ADDENDUM NO. 1

CRANDALL ISD – PERFORMING ARTS CENTER ADDITION TO CRANDALL HIGH SCHOOL

AUGUST 26, 2024

39-23712-00
 LEVEL 01 - AREA B - ELECTRICAL DEMOLITION PLAN

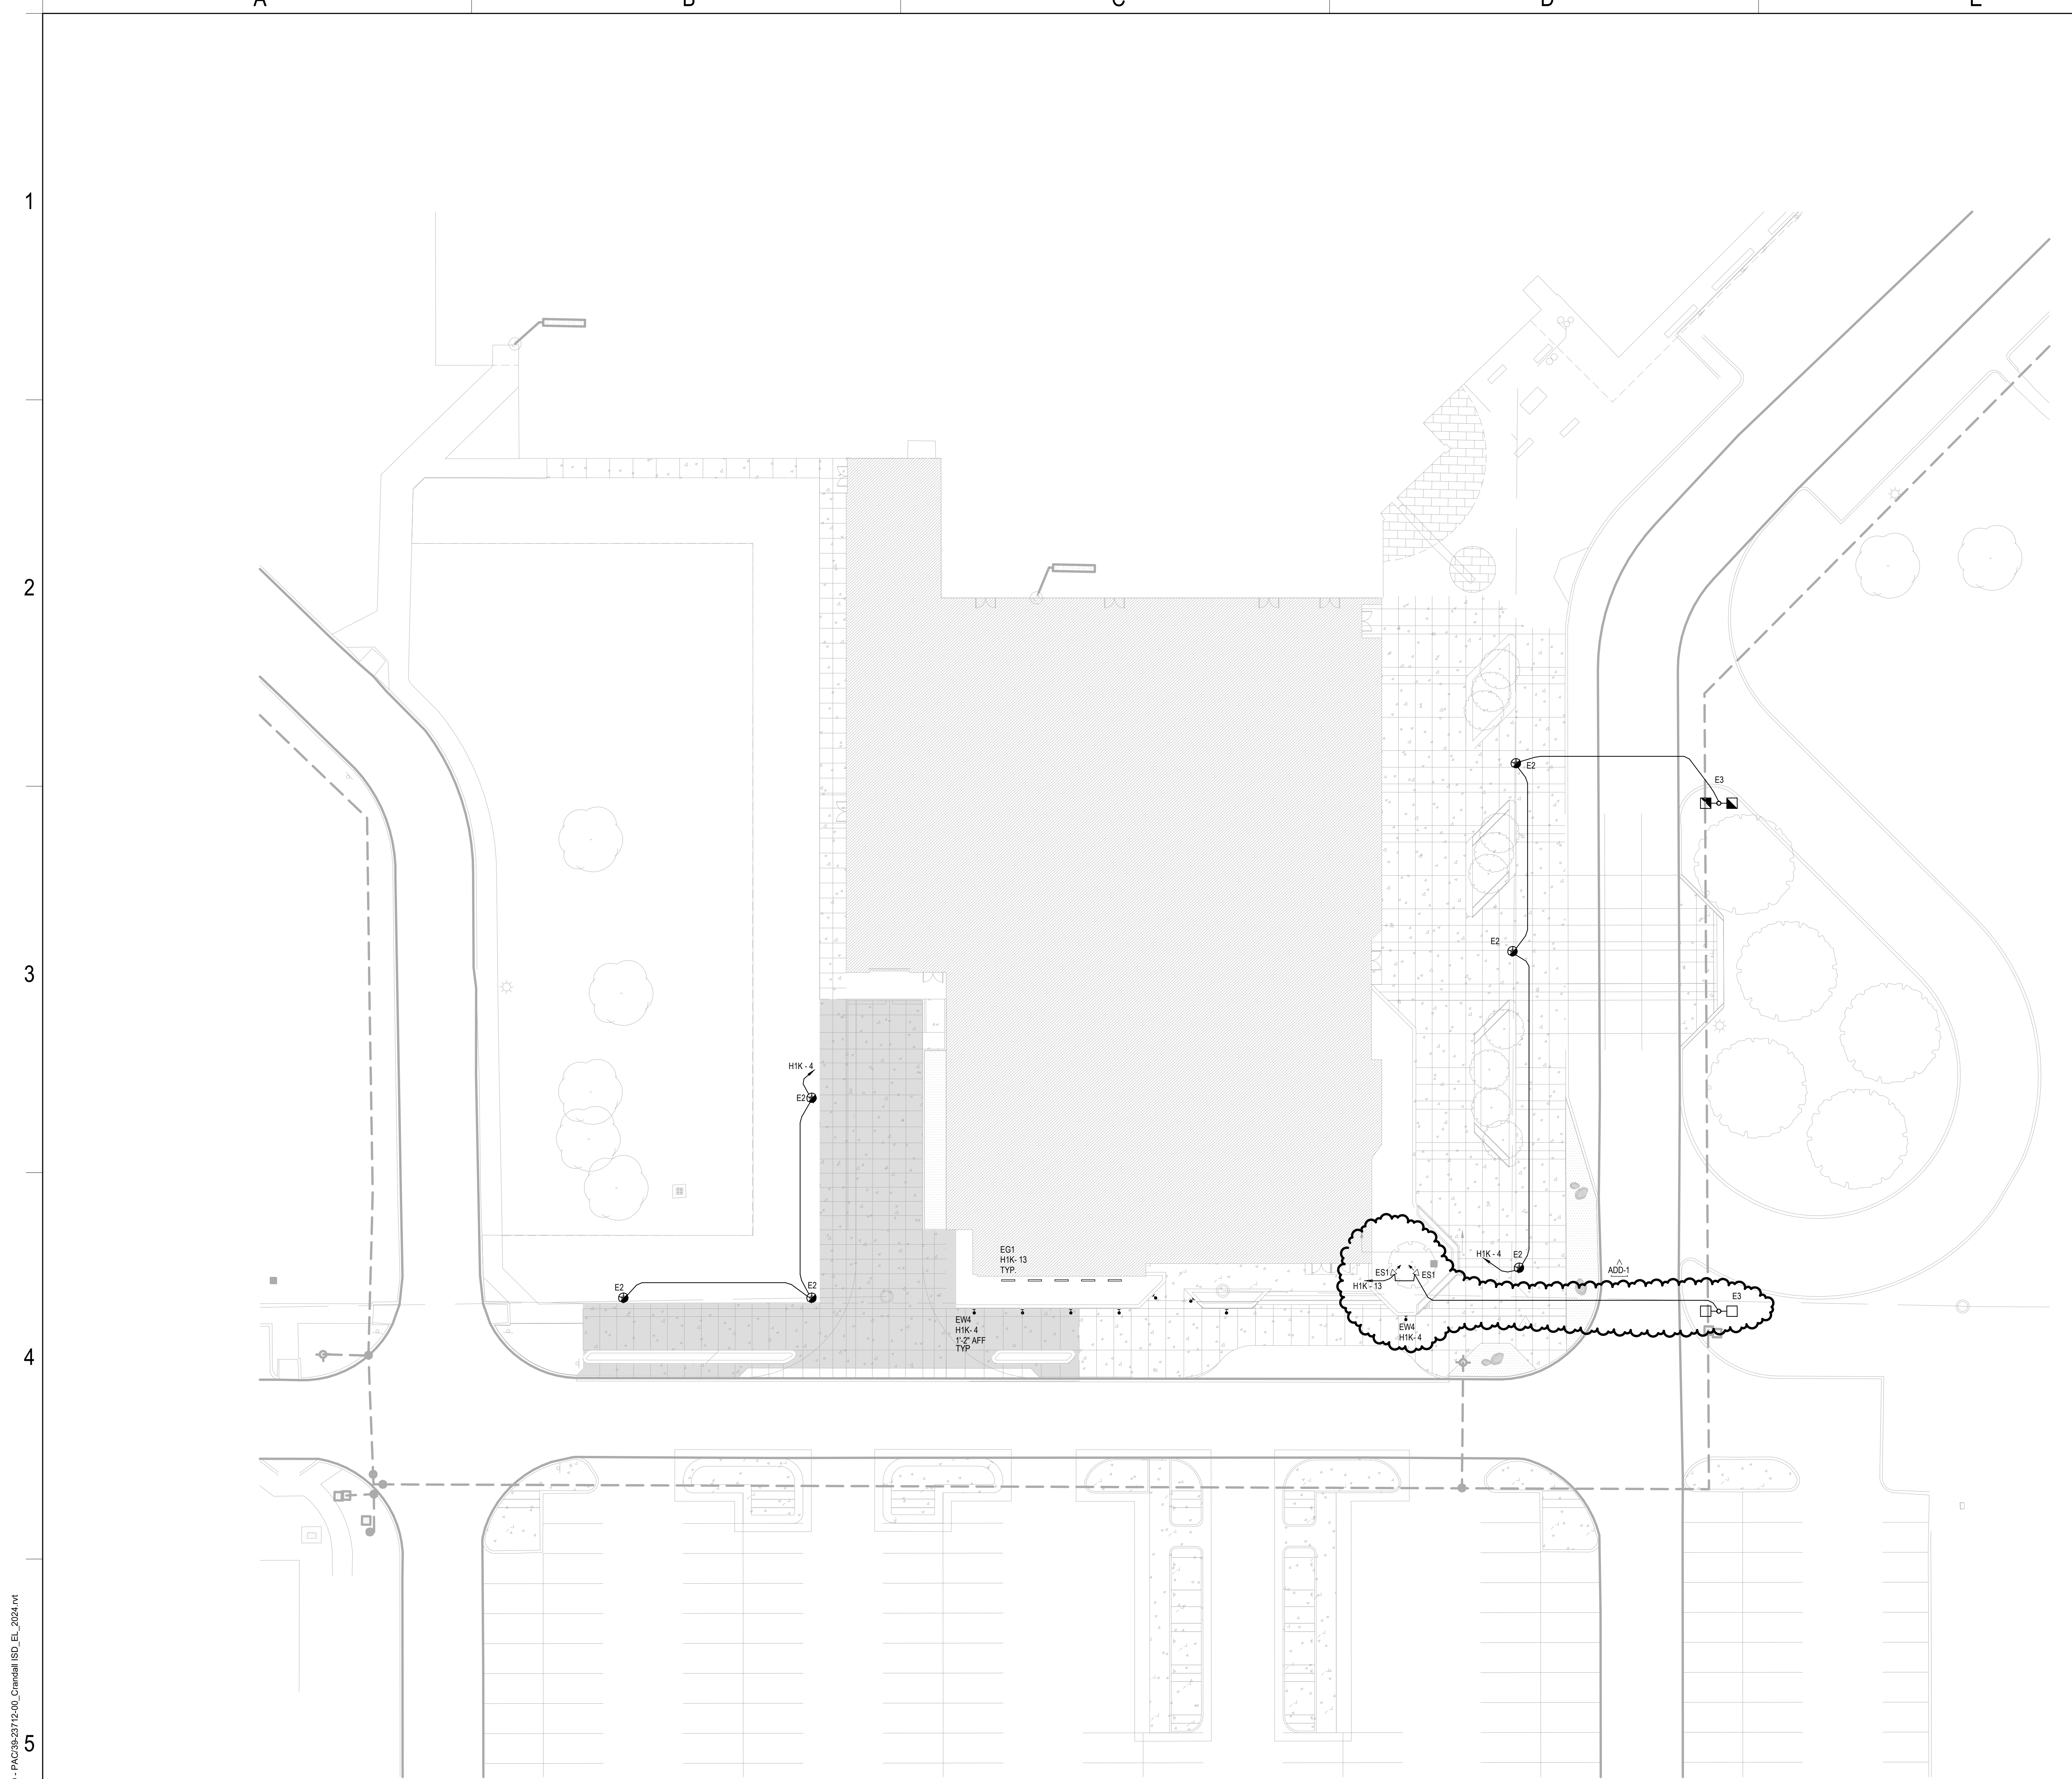
- ITEM 59. E0.1 – ELECTRICAL SYMBOLS, ABBREVIATIONS & NOTES – Symbols have been updated as indicated on the re-issued sheet.
- ITEM 60. ED1.1B – LEVEL 01 – AREA B – ELECTRICAL DEMOLITION PLAN – has been revised to include a note to protect overhead conduits as indicated on the re-issued sheet.
